2. The main PCB version from V1.3 changed to V1.7, only updated the GNSS module from LC79DA to LC79HA. (refer to the photos below)

According KDB178919 D01 Permissive change police V06 Section II., this modification does not affect RF characteristics and other RF performance, Software security remains unchanged from the original application, Radiated Spurious Emission tests were performed to verify RF compliance, and other test data please refer to original report.

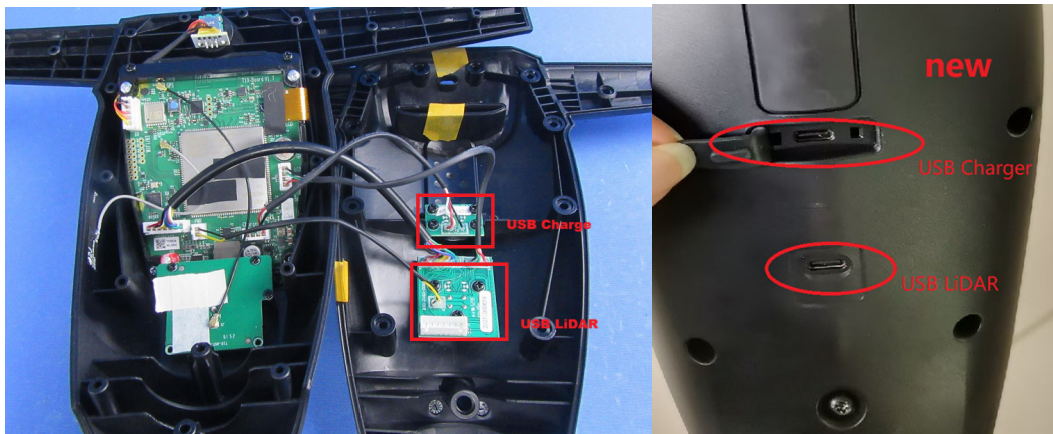
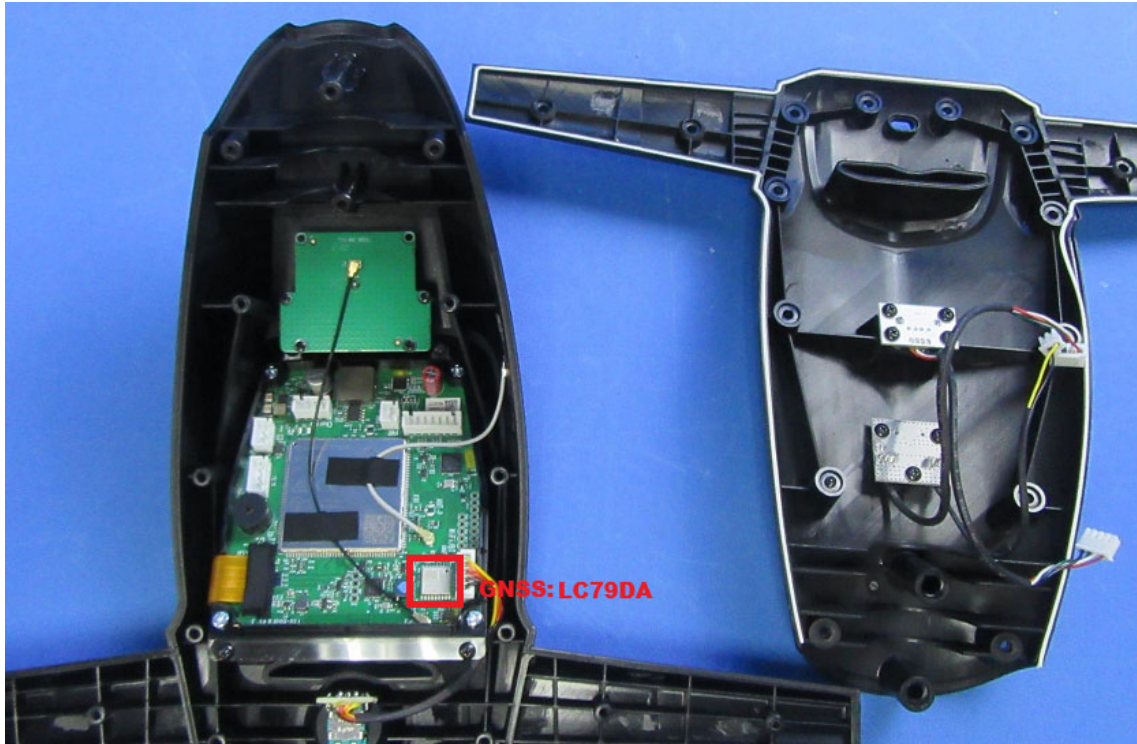
Old:

New:

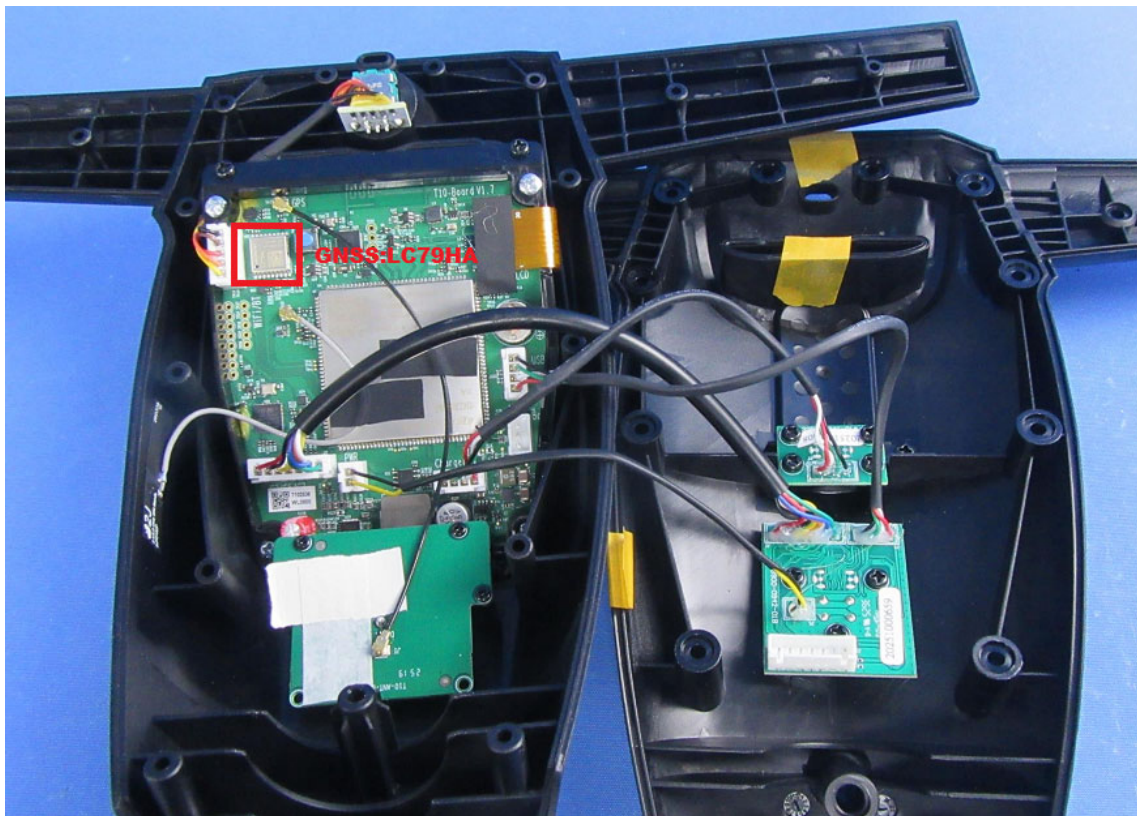
3. New Li-ion Battery and charger was used in the new model. (refer to the photos below)
